SLEDGE SUBDIVISION

APPLICATION NUMBER 5 DATE December 15, 2016
 APPLICANT Sledge Subdivision
 REQUEST Subdivision

DETAIL SITE PLAN

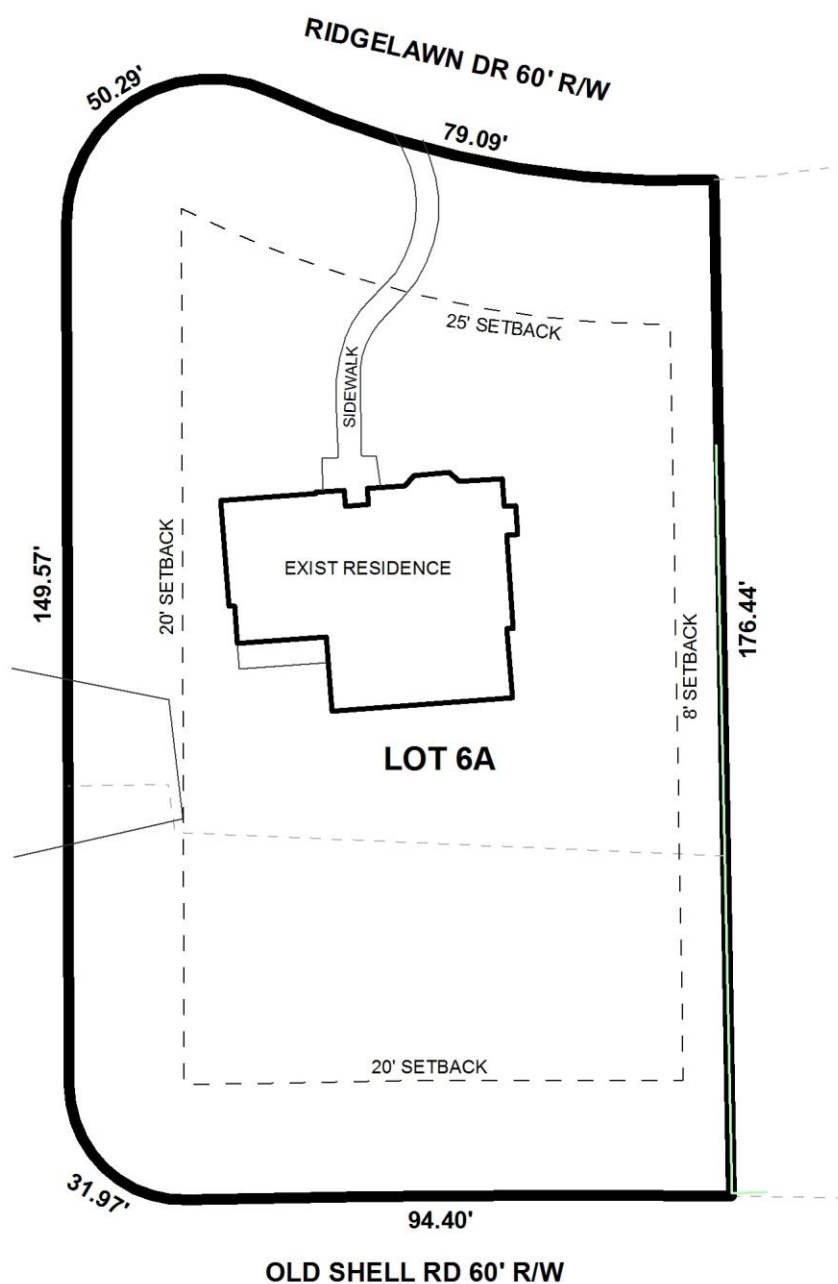
The proposed lot fronts Ridgelawn Drive, Ridgelawn Drive West and Old Shell Road. Both Ridgelawn Drive and Ridgelawn Drive West are minor streets with curb and gutter requiring a 50' right-of-way width. The preliminary plat indicates a 60' right-of-way width for both Ridgelawn Drive and Ridgelawn Drive West and, if approved, should be retained on the Final Plat. The site fronts Old Shell Road, also a minor street, and the existing right-of-way is illustrated as 60-feet. If approved, the right-of-way width should be retained on the Final Plat.

The preliminary plat illustrates a 25' minimum building setback along Ridgelawn Drive, a 20' minimum building setback along Ridgelawn Drive West, and a 20' minimum building setback along Old Shell Road. The preliminary plat also illustrates an 8' building setback from the East property line. Section V.D.9. of the Subdivision Regulations require a 25' building setback; however, Section 64-4.D.3. of the Zoning Ordinance allows for reduced setbacks for a side street on a corner lot, and the existing dwelling fronts Ridgelawn Drive. A waiver of the Section V.D.9. may be appropriate to allow the 20' setbacks. If approved, setbacks along all frontages should be retained on the Final Plat.

The proposed lot exceeds the 7,200 square foot minimum lot size requirements for lots served by public water and sanitary sewer systems. The preliminary plat provides the lot sizes in both square feet and acres and, if approved, should be retained on the Final Plat.

As a means of access management, a note should be placed on the Final Plat, if approved, stating that the proposed lot is limited to its existing curb cut, with any changes in the size, design and location to be approved by Traffic Engineering and conform to AASHTO standards.

- 1) Retention of 60' right-of-way width along Old Shell Road, Ridgelawn Drive and Ridgelawn Drive West;
- 2) Retention of the 25' minimum building setback line along Ridgelawn Drive;
- 3) Retention of the 20' minimum building setback line along Ridgelawn Drive West;

- 4) Retention of the 20' minimum building setback line along Old Shell Road;
- 5) Provision of the lot size information in both square feet and in acres;

- 6) Placement of a note on the Final Plat stating that the proposed lot is limited to its existing curb cut, with any changes in the size, design and location to be approved by Traffic Engineering and conform to AASHTO standards.
